Re: SEC Docket No. 2015-04: Public Service Company of New Hampshire d/b/a
Eversource Energy for a New 115k Transmission Line from Madbury Substation to
Portsmouth Substation
Applicant's Request for a Minor Modification to a Portion of the Underground
Alignment Across the University of New Hampshire Campus

SEACOAST RELIABILITY PROJECT CIRCUIT F-107 115kV UNDERGROUND TRANSMISSION LINE

UNH CAMPUS - DURHAM, NH

DISCIPLINE/SHT NO SHEET 4 OF 5 F10743002

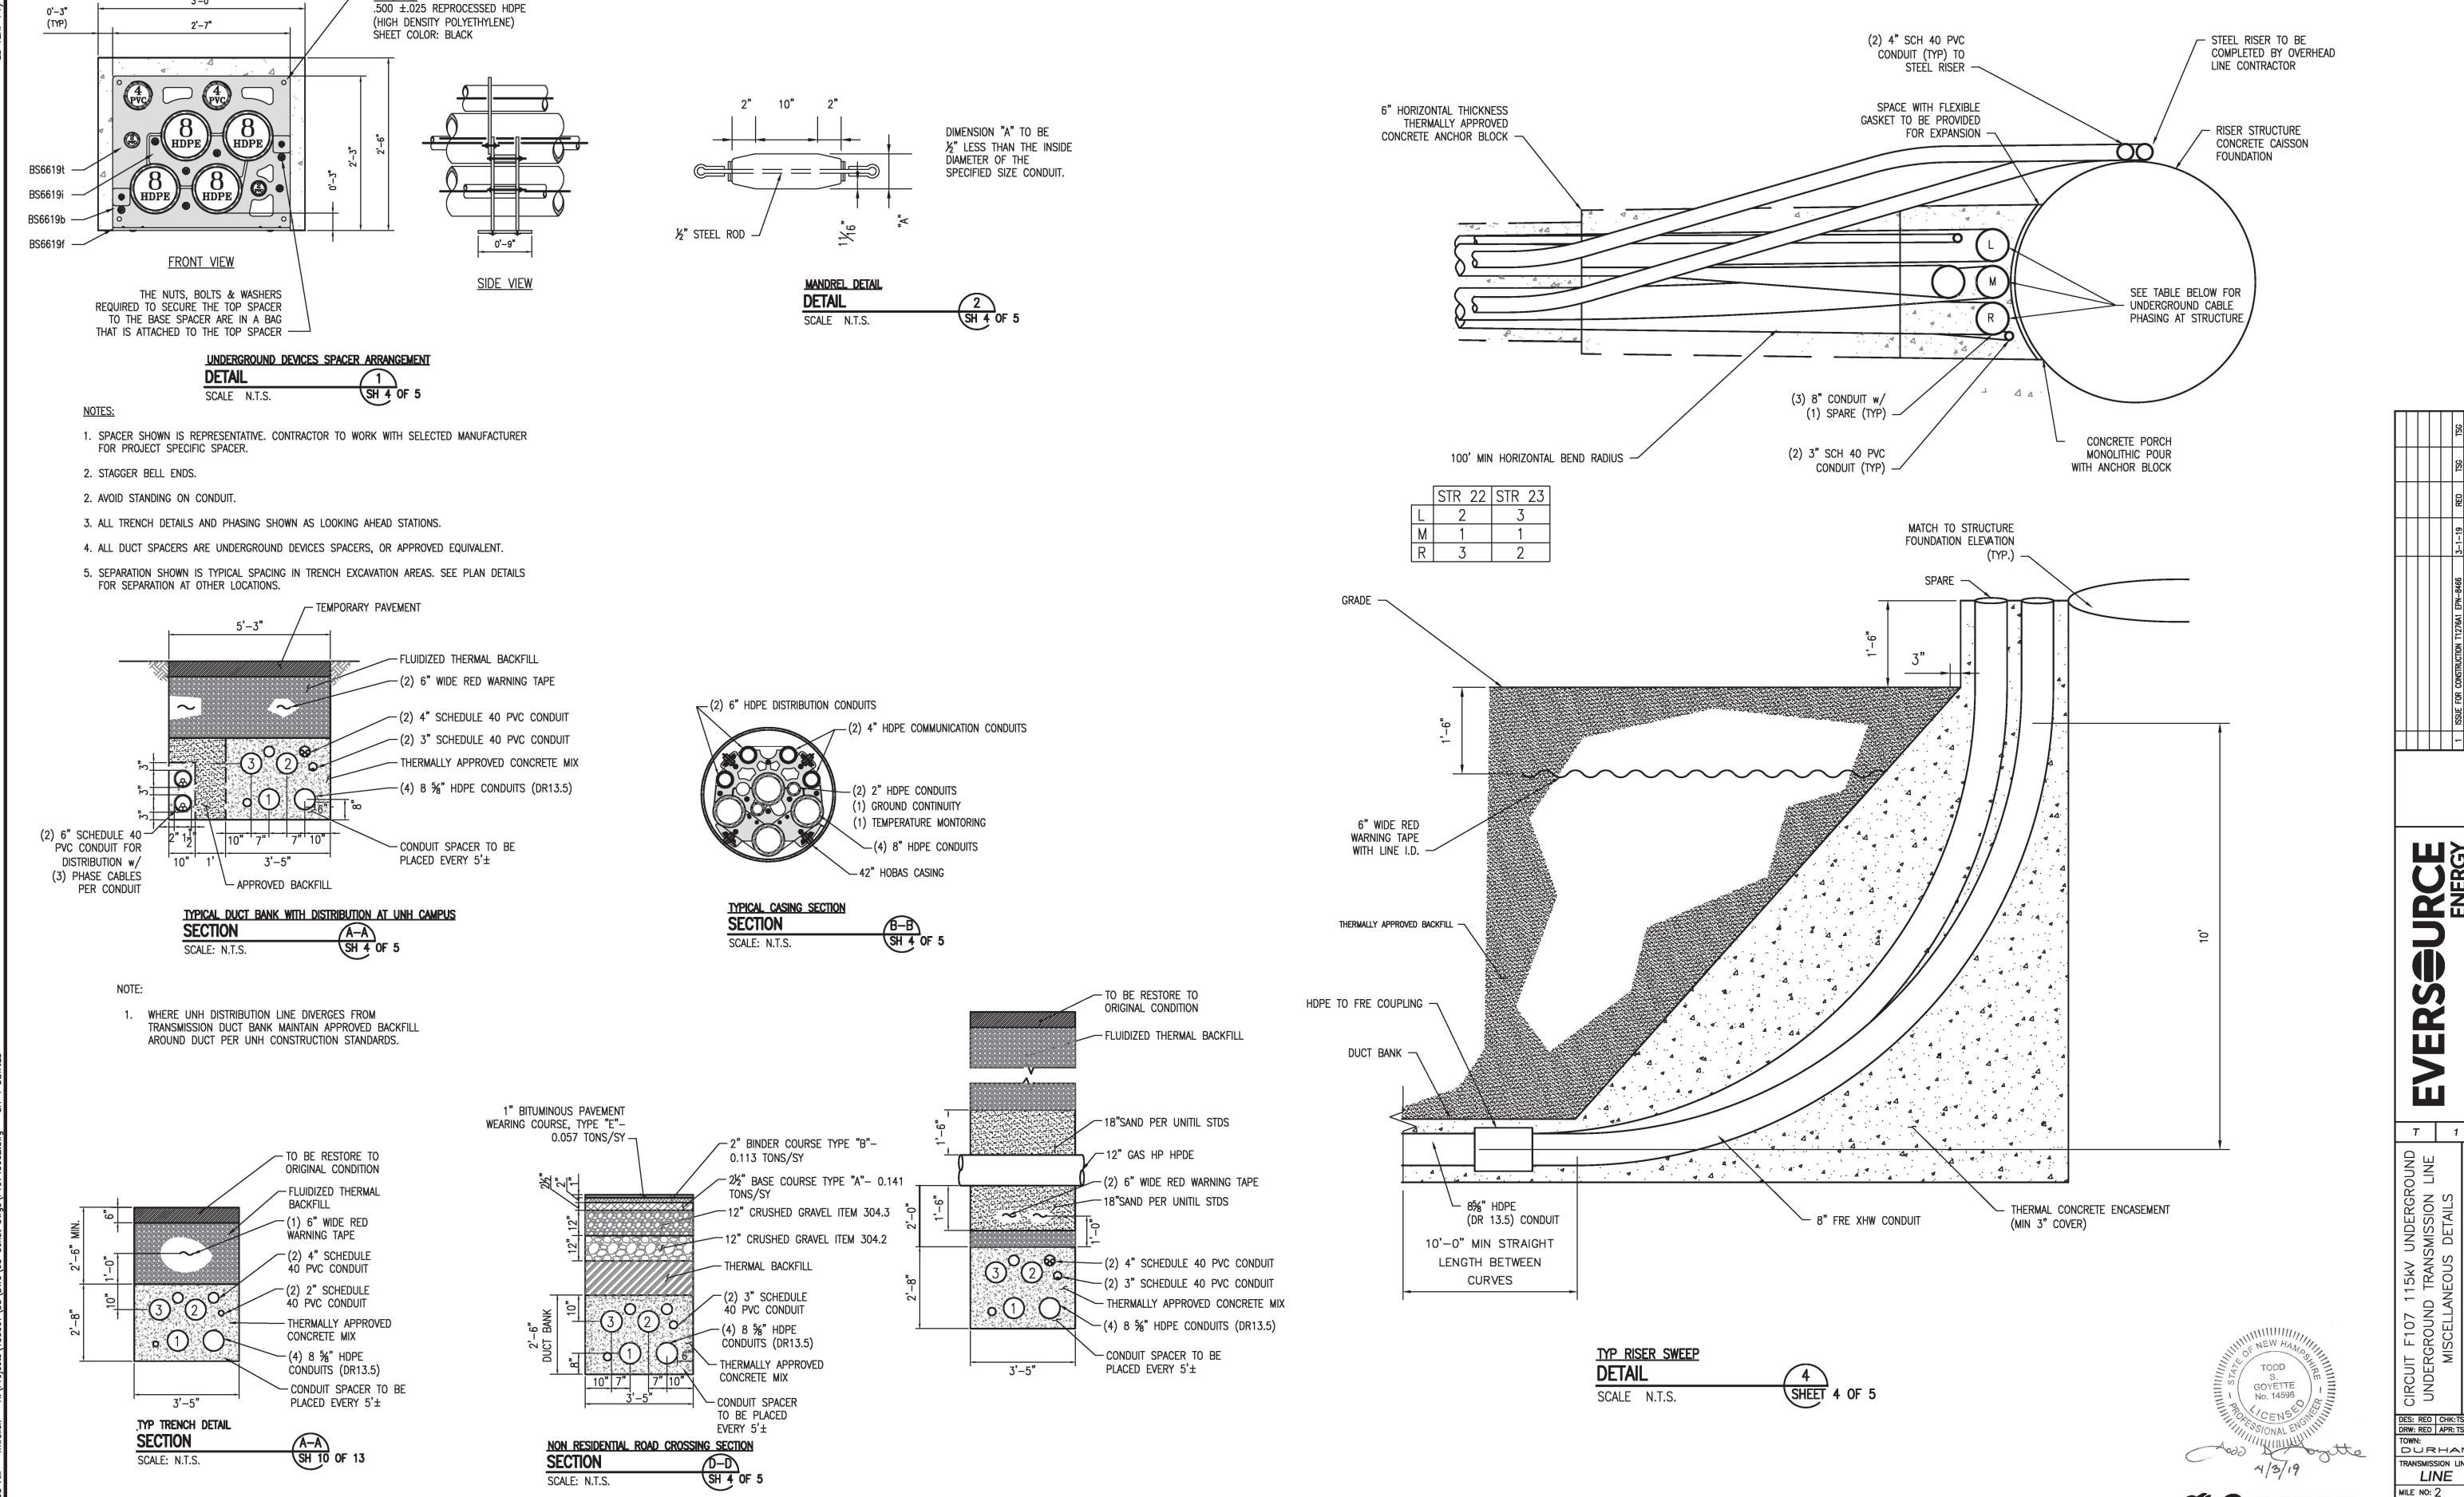
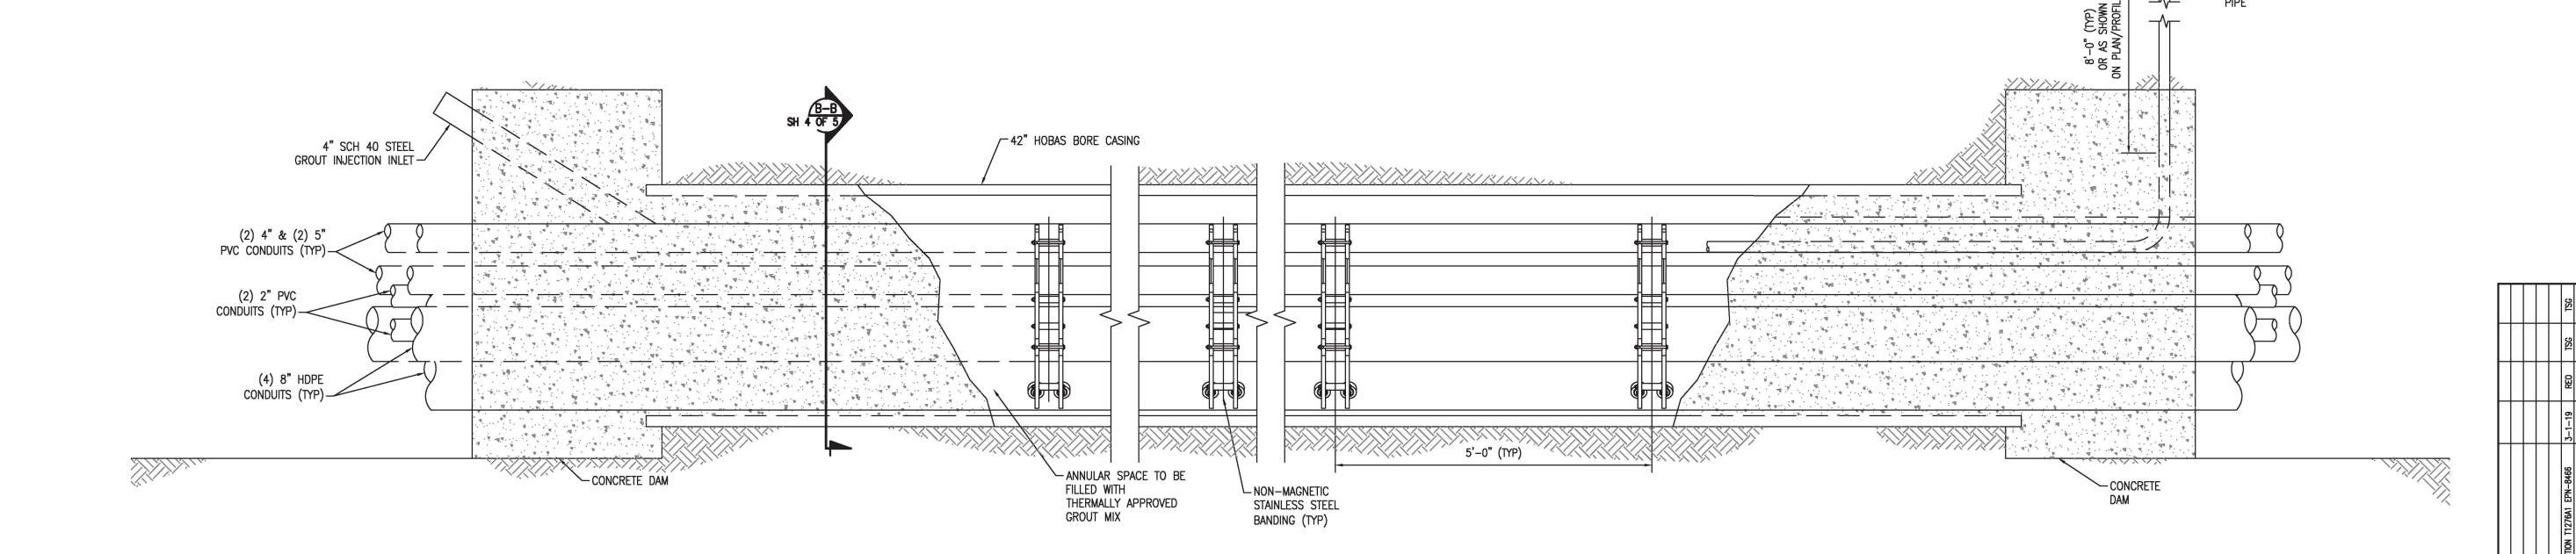
The proposed underground design on the UNH campus generally remains unchanged. As described in the Application, from proposed riser structure 22, the underground alignment will follow the edge of the UNH parking Lot A south towards Main Street. The line will pass under Main Street using a jack and bore trenching method as described in the Application. Once the Project crosses Main Street, the Project continues south along the original alignment until approximately station 85+50 (just south of the UNH Field House) as marked on the Revised UNH Engineering Drawings. *See* Attachment 2.

From that location, the new alignment will shift between three and ten feet east to avoid the new soccer field. The distance of the shift varies based on location of the line to the field and an existing methane gas line known as the Ecoline. This three to ten foot shift occurs between station 85+50 and College Brook (approximately station 89+50). The crossing of College Brook

is approximately eight feet closer to the existing Colovos Road Bridge then the previous location. See Attachment 2.

After crossing College Brook, the new alignment will generally be between 5 to 65 feet east of the approved design. This alignment change was also made at the request of UNH, brings the alignment closer to Colovos and Waterworks Road, and provides UNH with more buildable area for any future expansions without impacting the transmission line.

As part of the realignment, the underground transmission line was redesigned to maintain a minimum separation of four feet to the Ecoline where the two lines are parallel. In most cases the line is further than four feet. Where the two lines cross, the gas company, Unitil, requires a minimum of one-foot separation with 18 inches of sand around the pipe. As discussed above, the

new design will maintain a minimum of 24 inches of separation where the two lines cross per the Eversource standard, which is more restrictive.
